SUBJECT: ISSUANCE OF AMENDMENT NOS. 191 , 191 AND 188 TO FACILITY OPERATING
LICENSES DPR-38, DPR-47 AND DPR-55 - OCONEE NUCLEAR STATION,
UNITS 1, 2 AND 3 (TACS 80378/80379/80380)

The amendments modify specifications having cycle-specific parameter limits by
transferring these limits to a Core Operating Limits Report (COLR). In addition,
the specified height of the active fuel assembly is revised to incorporate a
new fuel design.

ATTACHMENT TO LICENSE AMENDMENT NO. 191

Replace the following pages of the Appendix "A" Technical Specifications with the enclosed pages. The revised pages are identified by Amendment number and contain vertical lines indicating the areas of change.

Figure 2.1-1
 Variable Low Pressure
 Protective Limits

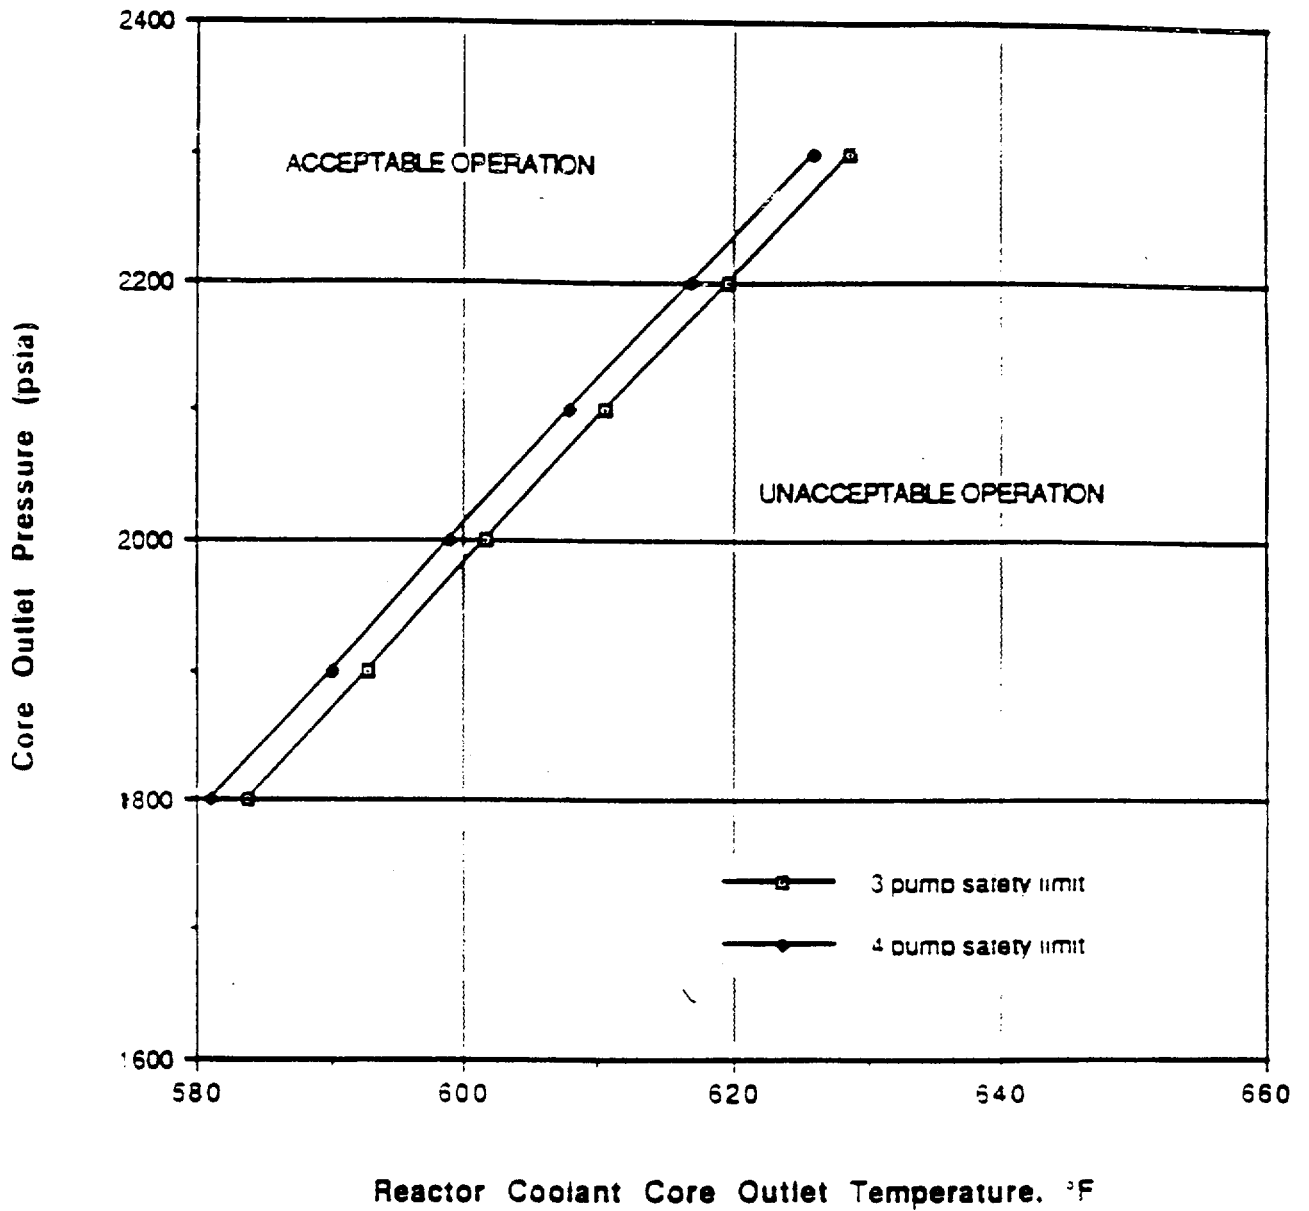
The curve presented in Figure 2.1-1 represents the conditions at which the minimum allowable DNBR is predicted to occur for the limiting combination of thermal power and number of operating reactor coolant pumps. This curve is based upon the design nuclear peaking factors provided in the Core Operating Limits Report.

Figure 2.1-2
 Axial Power
 Imbalance Protective Limits

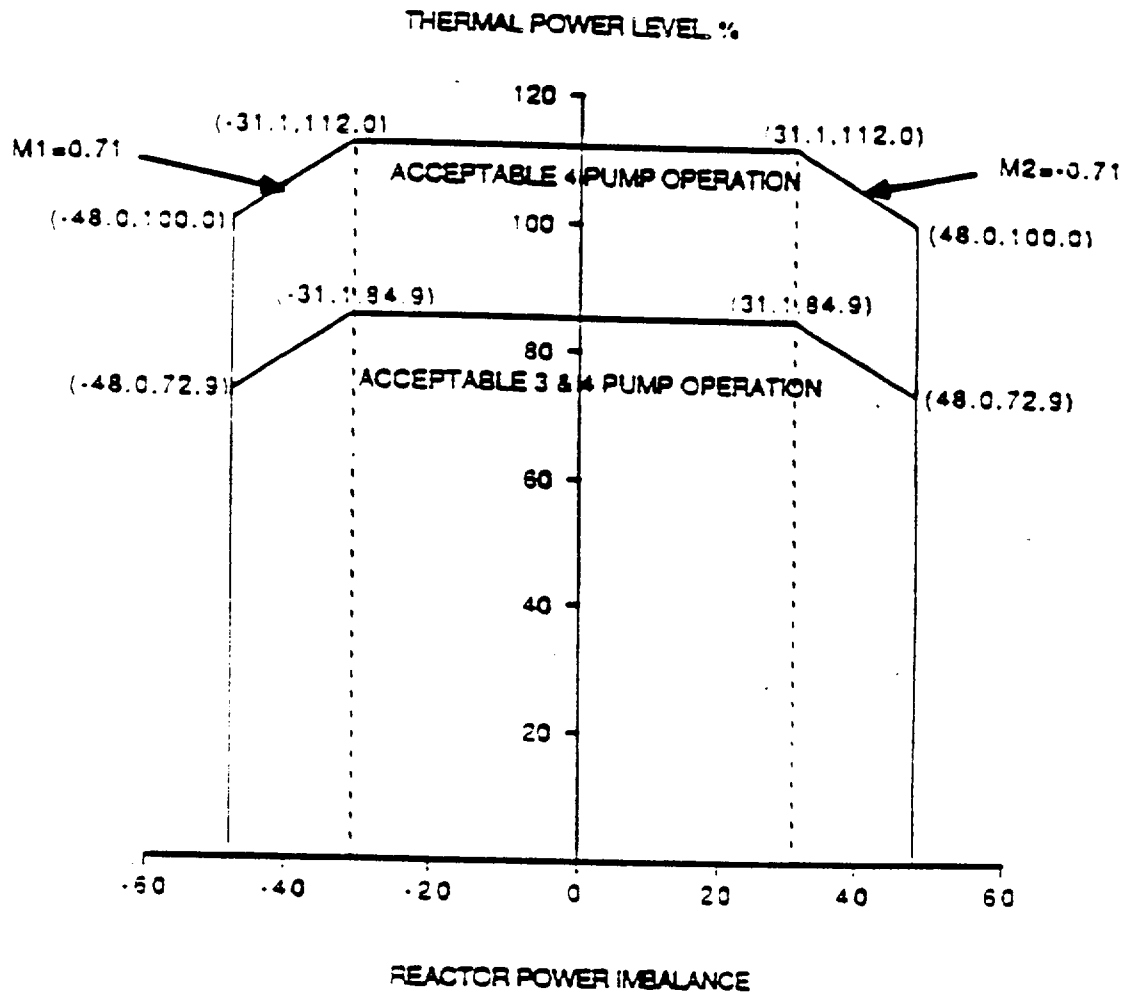
Since power peaking is not a directly measurable quantity, DNBR limited power peaks and fuel melt limited power peaks are separately correlated to measurable reactor power and power imbalance. The reactor power imbalance limits, Figure 2.1-2, define the values of reactor power as a function of axial imbalance that correspond to the more restrictive of two thermal limits - MDNBR equal to the DNBR limit or the linear heat rate equal to the centerline fuel melt limit.

The core protection safety limits are based on an RCS flow less than or equal to 385,440 gpm (4 pump operation). Three pump operation is analyzed assuming 74.7 percent of four pump flow. The maximum thermal power for three pump operation is provided in Figure 2.1-2.
